YAESU FT-450D 20dB ATT disabled below 1700kHz

RF-IF-UNIT (BRO)

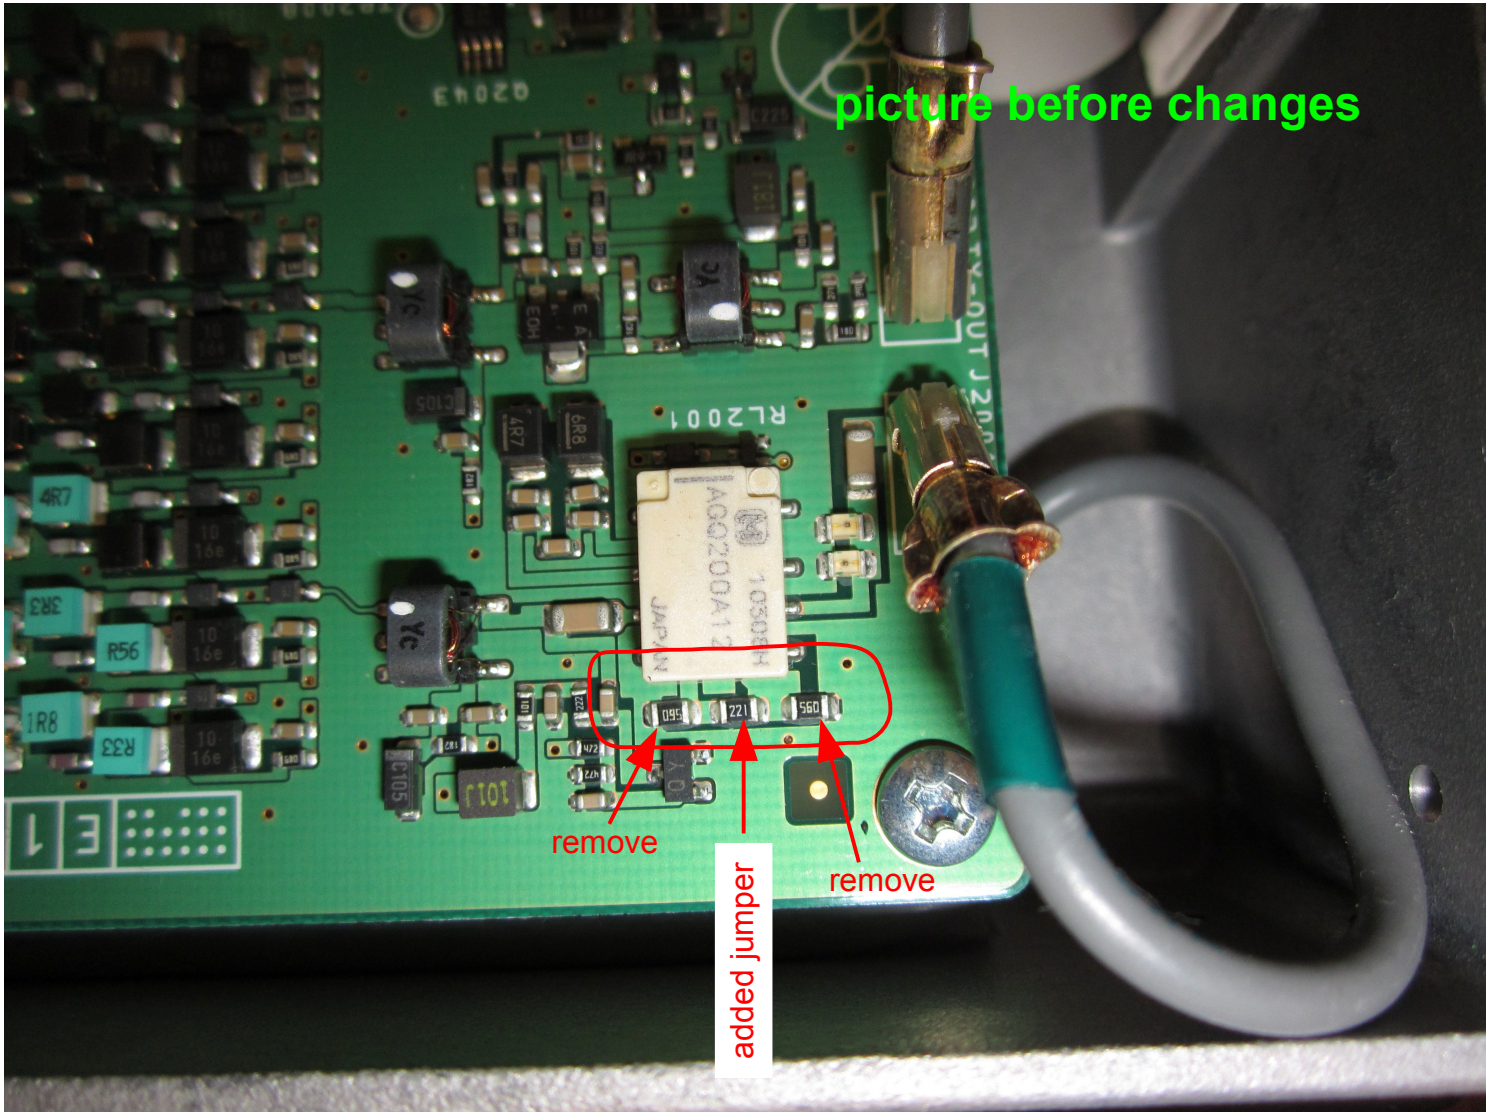
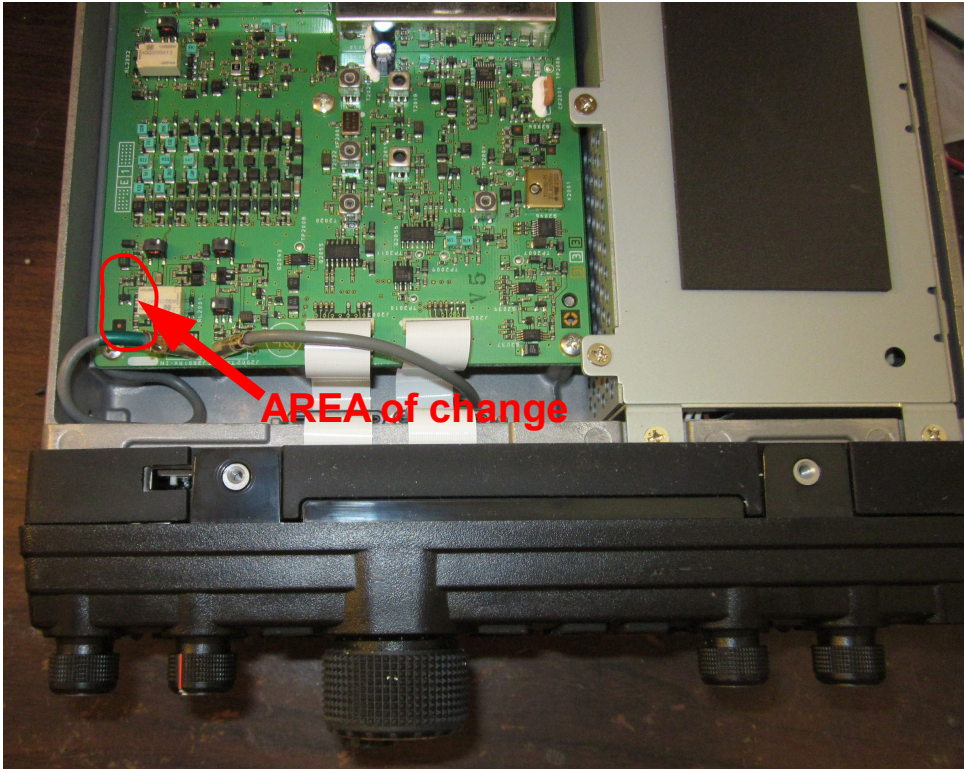
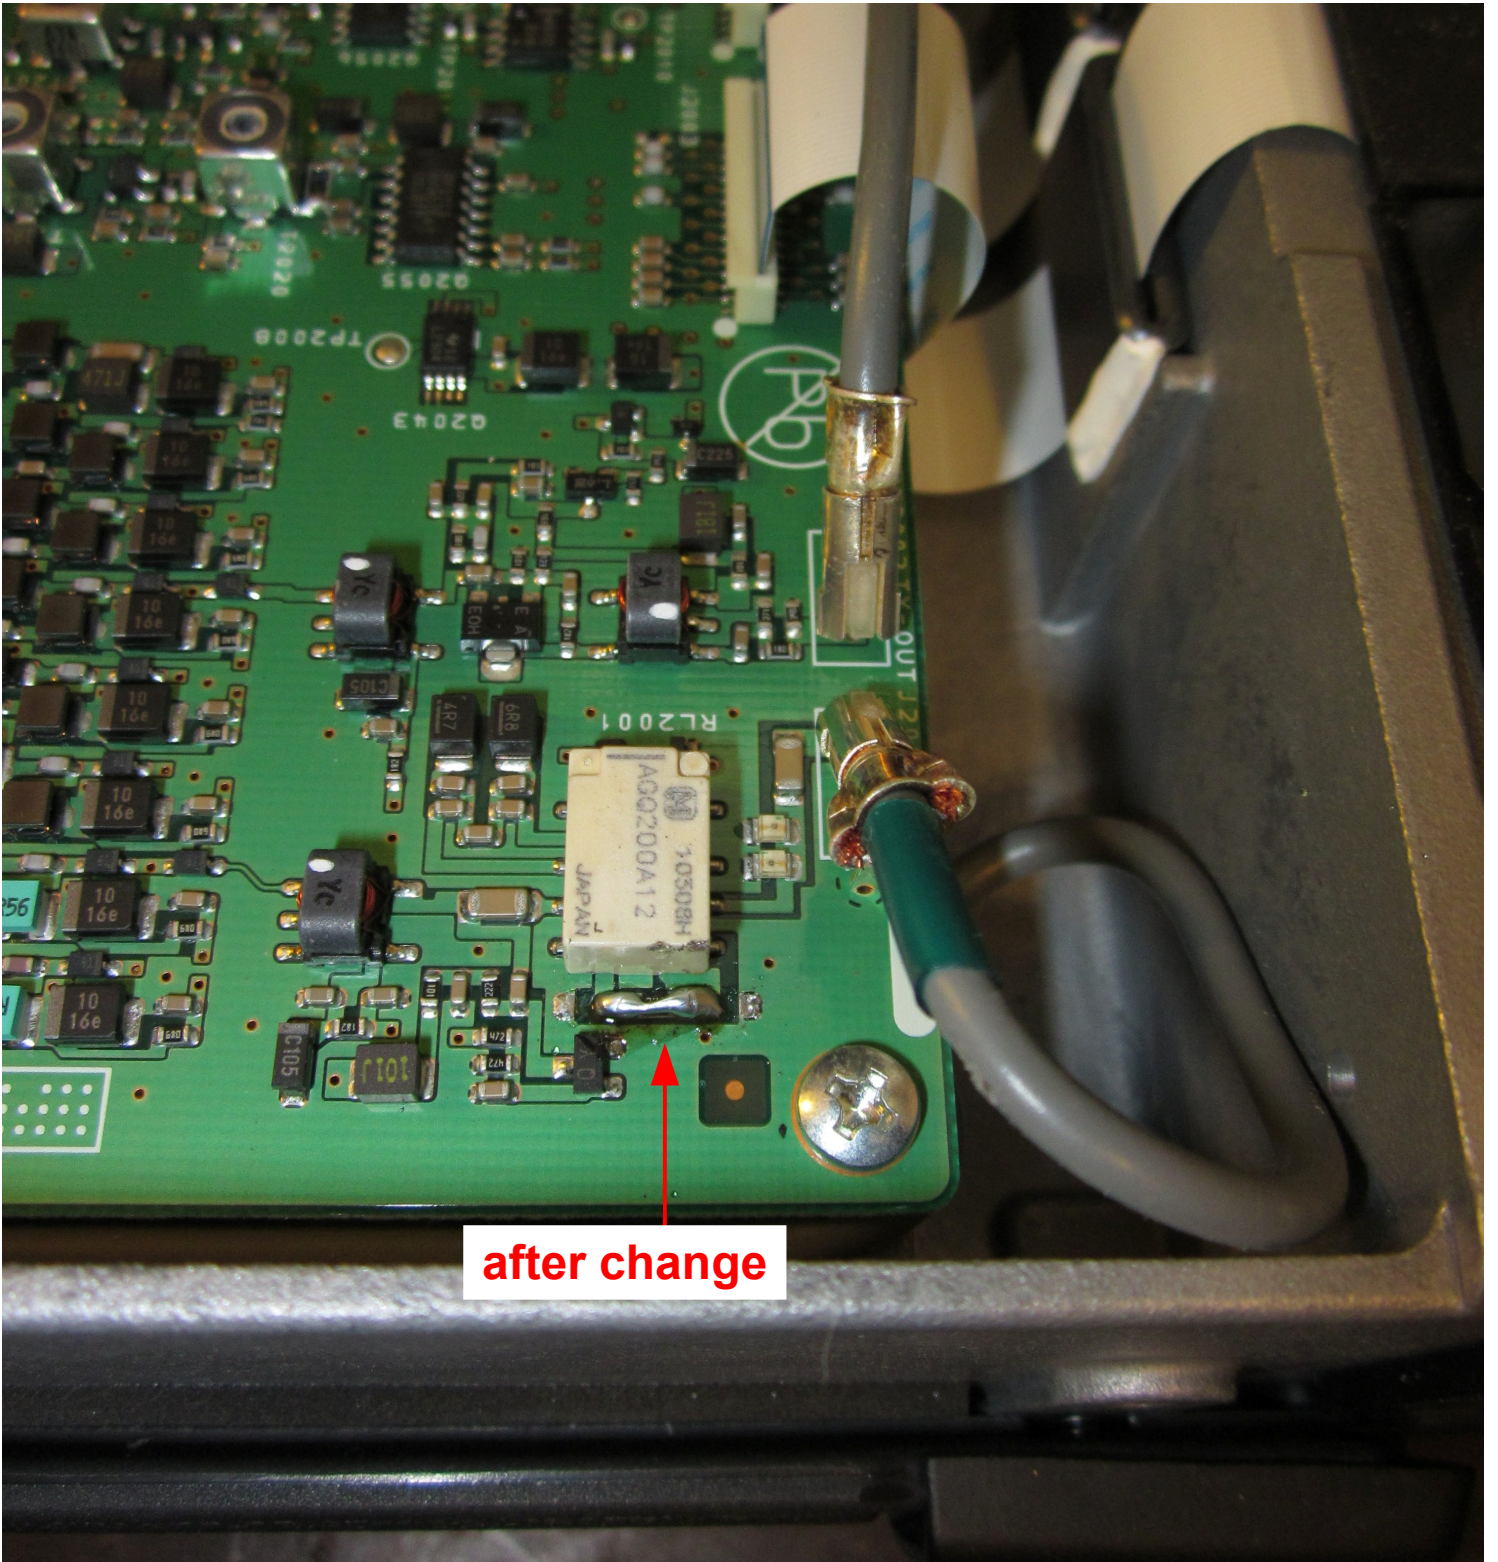
at frequency below 1700kHz, even the display say ATT is ON, 20dB ATT is jumper through with 0 ohm jumper (0dB ATT).

after change
